ELK RIDGE ADDITION

SEDGWICK COUNTY, KANSAS

RE: SUB 2003-148 -- Final Plat of Elk Ridge Addition

STAFF REPORT

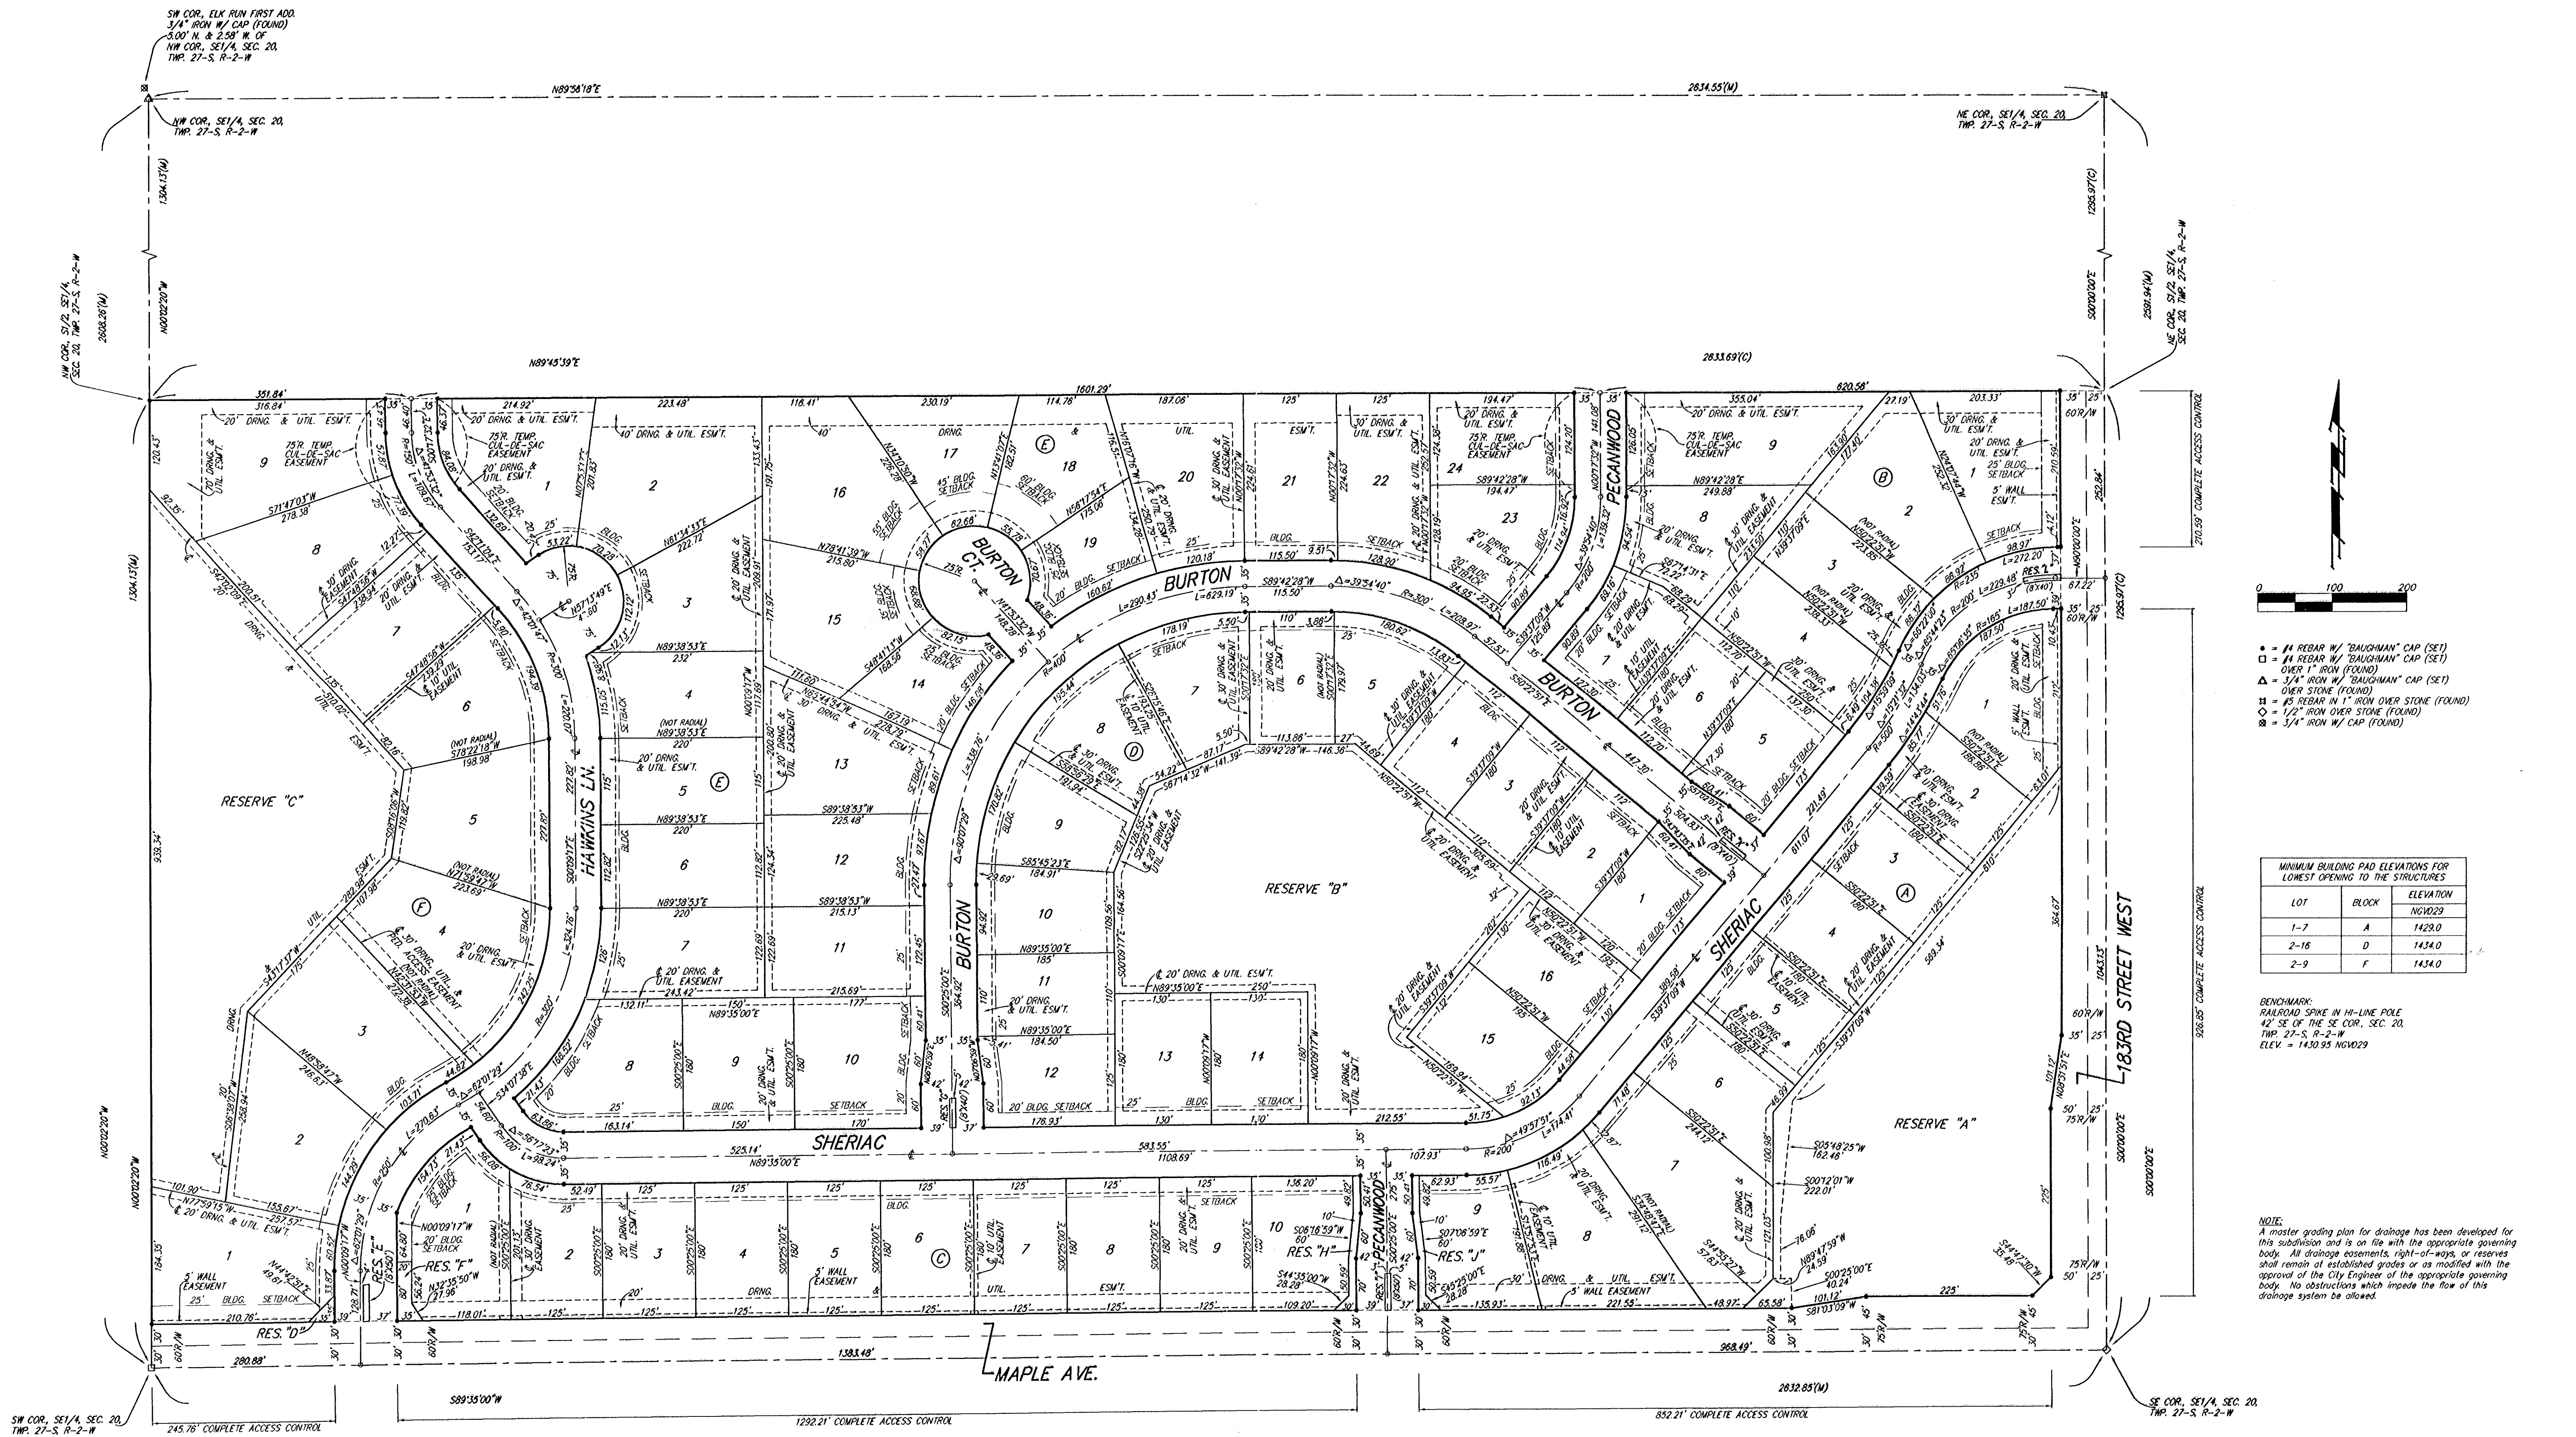
- A. This plat will be subject to approval of the associated zone change and any related conditions of such a change. Prior to this plat being considered by MAPC, the zone change will need to be approved.

- B. Sewer and water services will be provided from Goddard. The Applicant shall submit a letter to that effect.
- C. If improvements are guaranteed by petition, a notarized certificate listing the petitions shall be submitted to the Planning Department for recording.

- D. County Engineering needs a drainage plan and a flood study, with minimum pads based on those results. Additional drainage easements may be needed based on the study. A Division of Water Resources permit may be needed.

- E. Since the subdivision is in a FEMA-regulated floodplain, the floodway certificate needs added.
- F. Access needs to be provided to Reserve A for maintenance from Sheriac.

- G. The temporary and permanent cul-de-sacs should have a 75-ft radius.
- H. The applicant shall guarantee the closure of any driveway openings located in areas of complete access control or that exceed the number of allowed openings.

- I. Per Sedgwick County Fire Department, access drives to any structure in excess of 150 feet from the edge of the roadway will need to be installed prior to final framing inspection, preferably before the start of any above grade construction work. Such drive to be installed according to fire department specifications: (1) Twenty feet of drivable surface is provided the entire length of the access drive designed to withstand the weight of fire apparatus in inclement weather with provisions for turning fire apparatus around. (2) To meet fire department specifications, the surface will need to be an all-weather material consisting of rock or gravel, ground asphalt, laid asphalt or concrete. It is to be applied a minimum of 4 inches in depth consistently over the entire width and length of the driving surface (gravel is prone to problems during extended periods of rain or snow and should be used with caution unless a good solid compacted base has been installed).

- J. The 70-ft street right-of-way is not permitted to serve lots under 25,000 sq. ft. The applicant will need to increase the size of the lots or in the alternative guarantee the paving of the proposed streets to the 64-ft urban street standard. The Subdivision Committee has approved a modification to permit the 70-ft streets in conjunction with the suburban street pavement standard.

- K. The street guarantee shall include the installation of a temporary turnaround at the terminus of Hawkins Lane and Autumn at the plat's north line. The plat's text should indicate that the vacation of the temporary turnarounds area will be effective upon the extension of the streets northward.

- L. It is recommended that Reserve C be extended to the street by access easements or by narrow strips of Reserve between the lots to increase its accessibility and usefulness for all homeowners in the Addition.

- N. For those reserves being platted for drainage purposes, the required covenant which provides for ownership and maintenance of the reserves shall grant, to the City, the authority to maintain the drainage reserves in the event the owner(s) fail to do so. The covenant shall provide for the cost of such maintenance to be charged back to the owner(s) by the governing body.

- Q. The plat's text shall include language that a drainage plan has been developed for the plat and that all drainage easements, rights-of-way, or reserves shall remain at established grades or as modified with the approval of the applicable City or County Engineer, and unobstructed to allow for the conveyance of stormwater.

- Y. The representatives from the utility companies should be prepared to comment on the need for any additional utility easements to be platted on this property. SBC has requested additional easements.

A pedestrian access easement has been platted as requested.
- M. Provisions shall be made for ownership and maintenance of the proposed reserves. The applicant shall either form a lot owners' association prior to recording the plat or shall submit a covenant stating when the association will be formed, when the reserves will be deeded to the association and who is to own and maintain the reserves prior to the association taking over those responsibilities.
